RE: October 31, 2000 fax to Cubic Communications, Inc., Mr. Clive Winkler
FCC ID: NVSMTC-100TMCPA

Re: Application dated 10/11/00 and granted 10/31/00
Applicant Name: Cubic Communications Inc
Equipment Class: TNB-Licensed Non-Broadcast Station Transmitter
FCC ID: NVSMTC-100TMCPA

A. In response to Item 1 of The FCC communication from Kenneth Nichols dated 10-31-00.

Output Bandwidth vs Audio Input Level

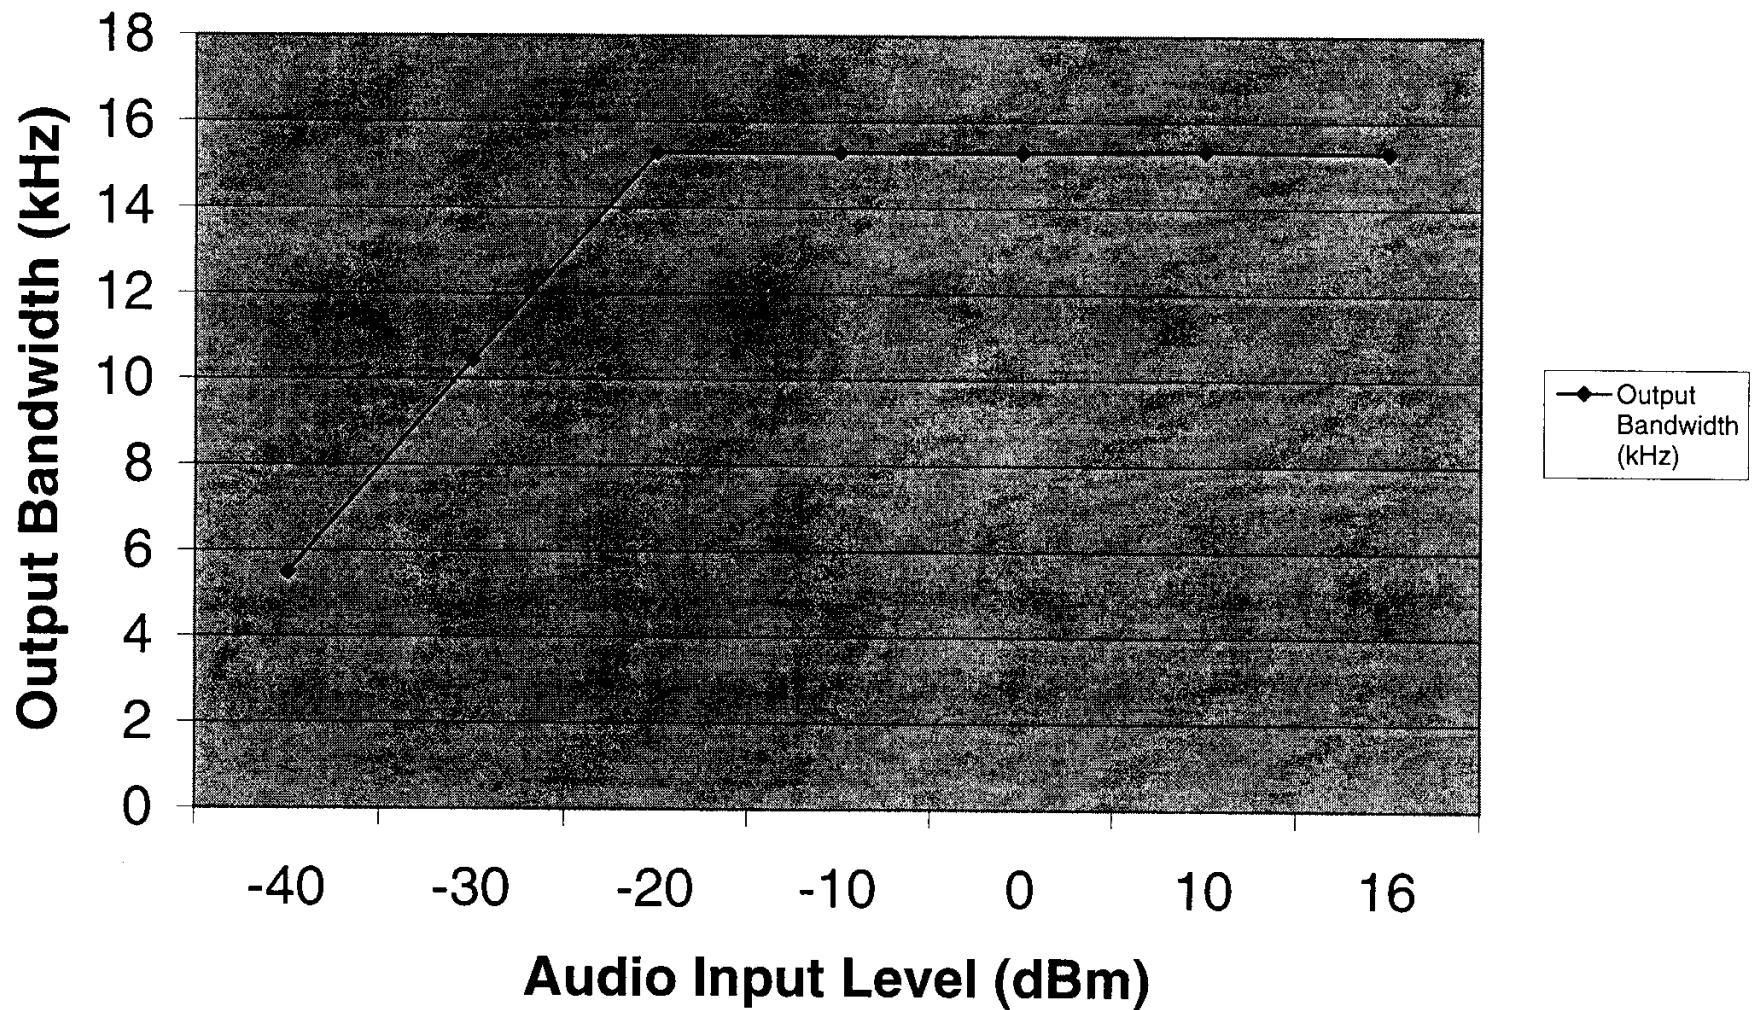
“Modulation limiting data required by Section 2.1047(b) of the FCC Rules was not submitted.”

We have attached measured data taken on 11/21/00 according to this specification.

Data and Plot of the Output Bandwidth vs the Audio Input Level.

See page 4 for the plot of the data and pages 5 through 11

16	15.29
10	15.34
0	15.29
-10	15.29
-20	15.29
-30	10.45
-40	5.50

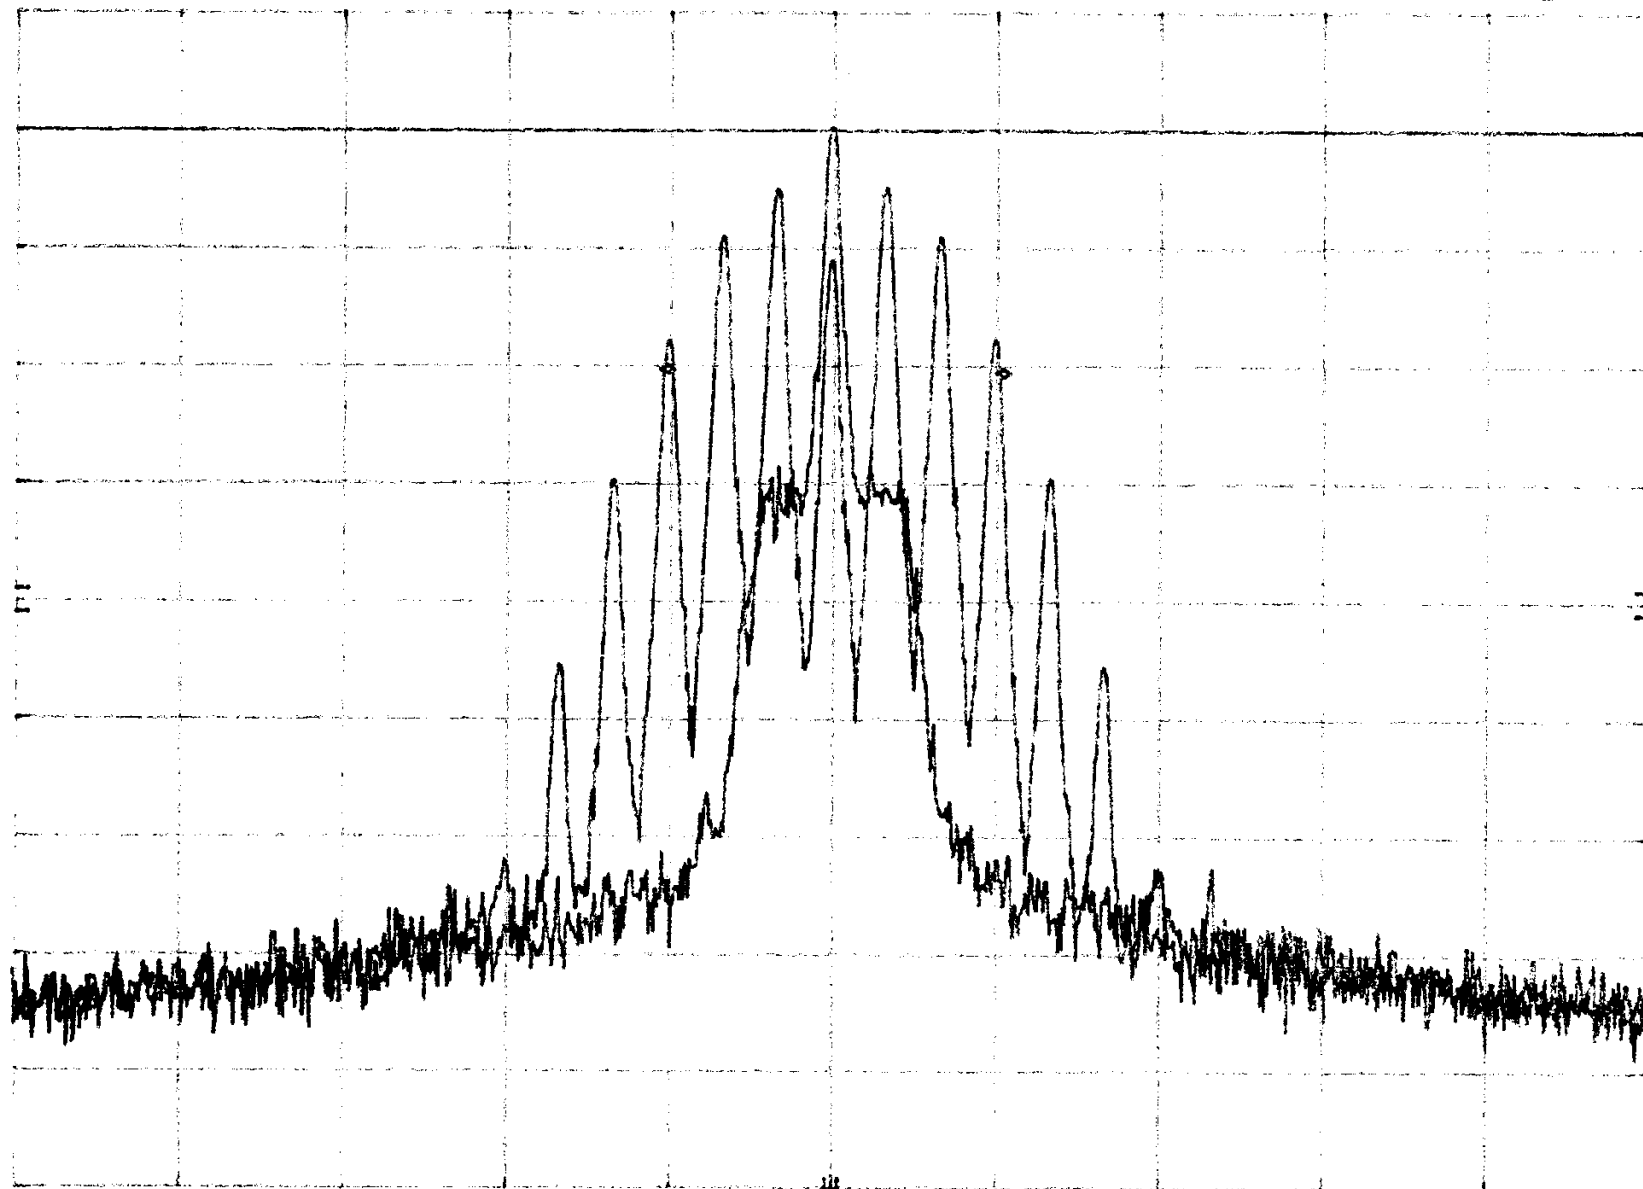
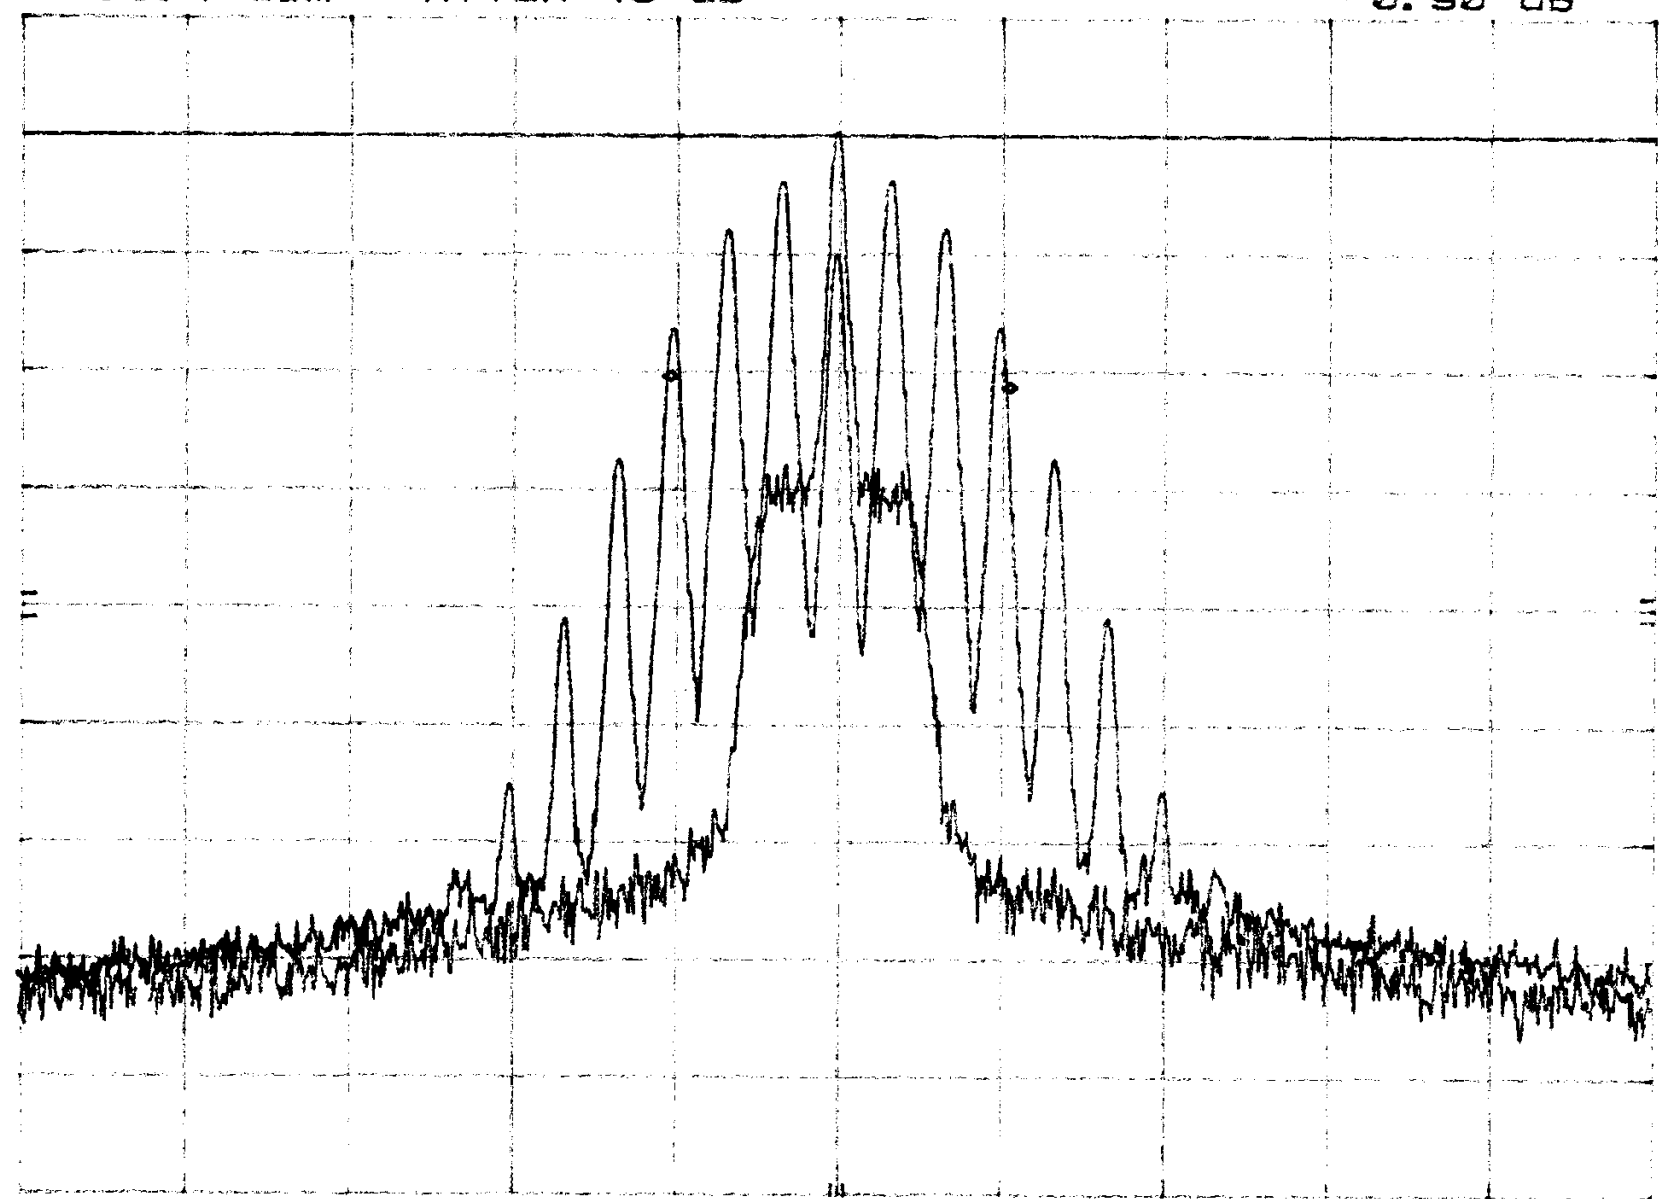
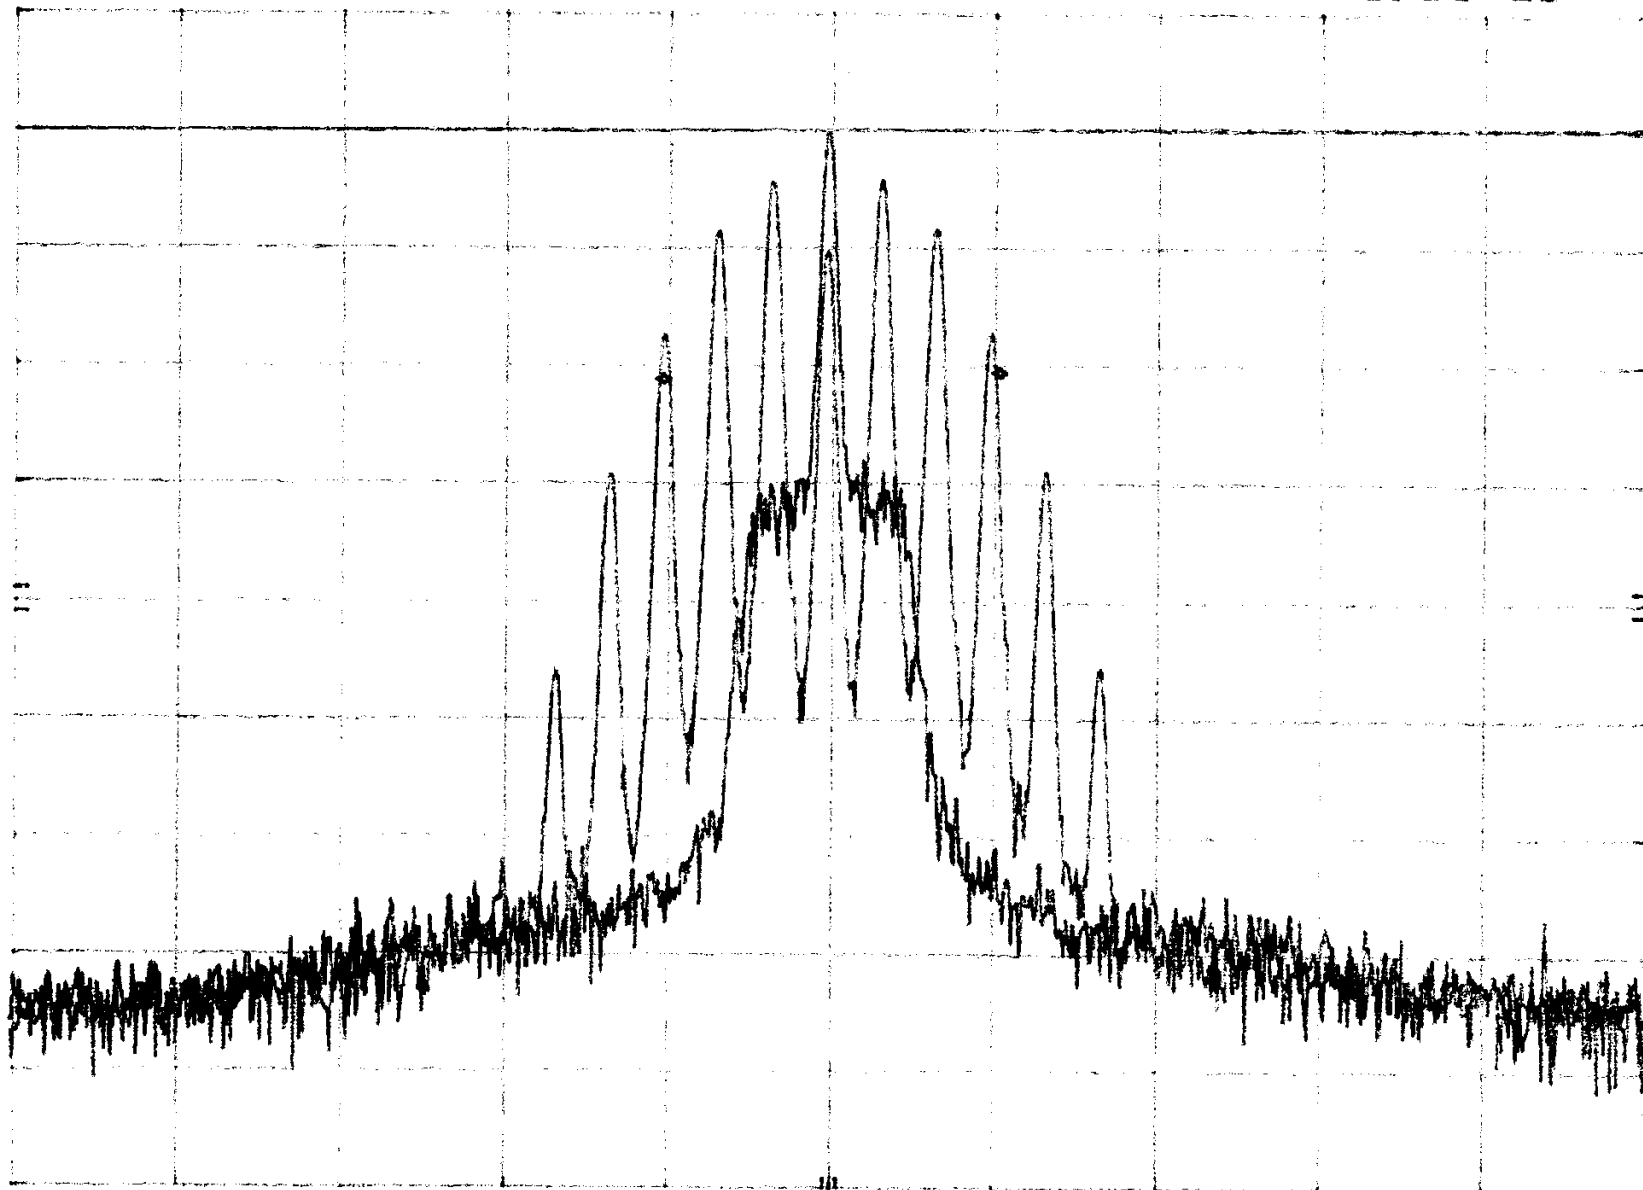
“The occupied bandwidth test was not made with the 2500 Hz tone prescribed by Section 2.1049 (c)(1) the Rules.”

We have attached measured data taken on 11/02/00 and 11-21-00 according to this specification. See pages 5 and 12 through 14
